Attachment-12 Departmental and Agency Comments

Date November 20, 2023
To **Kelley McCormick, Senior Planner**
From Michelle Thalen, C.Tech
Engineering Technologist III
Service Area Infrastructure, Development and Enterprise Services
Department Engineering and Transportation Services
Subject **331 Clair Road East**
OZS23-007
Submission 1

Date	November 20, 2023
To	Kelley McCormick, Senior Development Planner
From	Perit Kaji, Planner II- Development and Urban Design
Service Area	Infrastructure, Development and Enterprise Services
Department	Planning Services
Subject	331 Clair Road E.: Zoning By-law Amendment Application – OZS23-007 Urban Design Comments

Re: Zoning By-law Amendment Application OZS23-007
331 Clair Road East, City of Guelph
MHBC Planning/2488995 Ontario Ltd.

Enclosed: GRCA Map of Subject Property

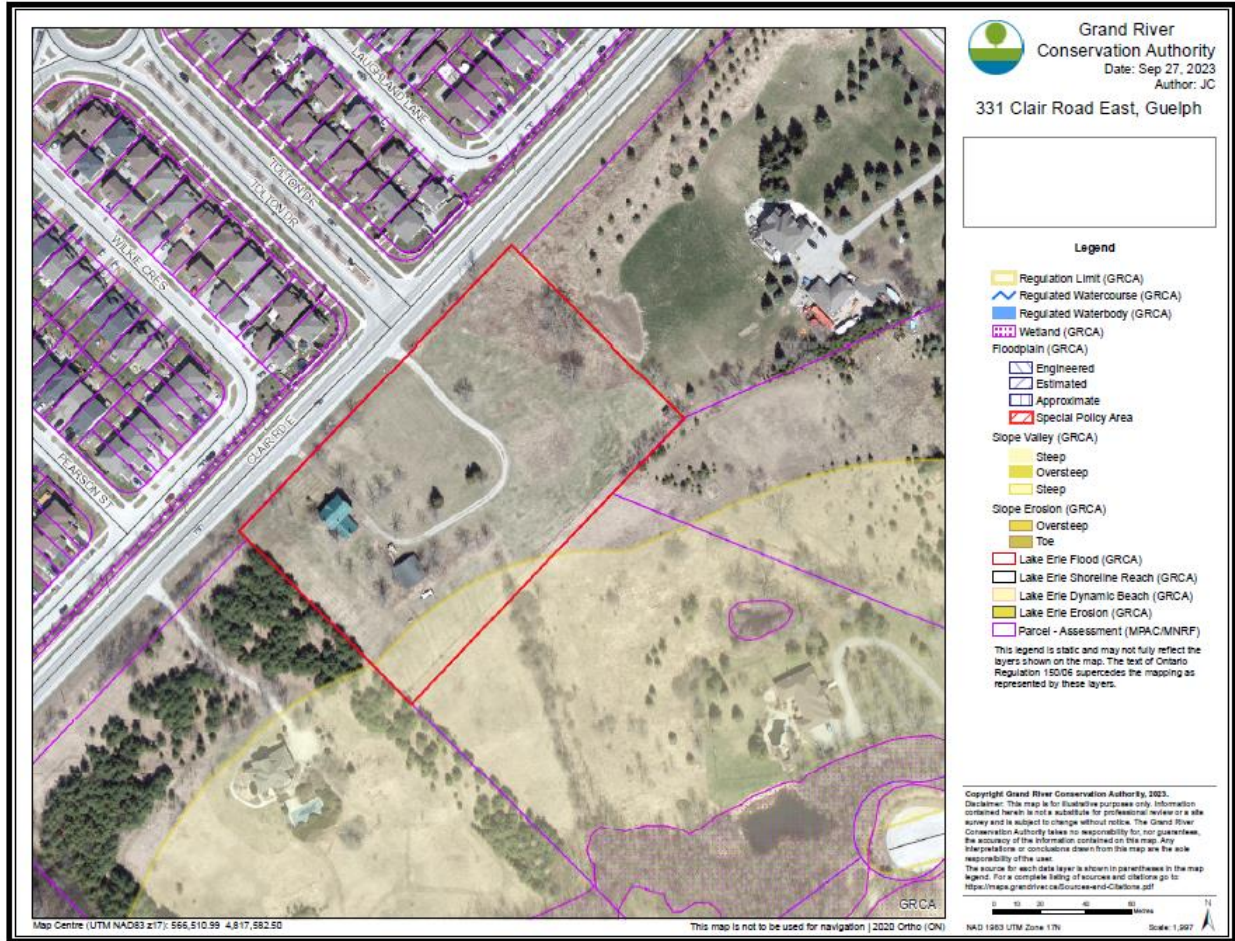
Information currently available at this office indicates that a portion of the subject property is within the regulated allowance to wetland located south of the subject property. A copy of our resource mapping is attached.

Due to the presence of the wetland, a portion of the subject property is regulated by the GRCA under Ontario Regulation 150/06 (Development, Interference with Wetlands and Alterations to Shorelines and Watercourses Regulation). Any future development or site alteration within the regulated area on the subject property will require a GRCA permit.
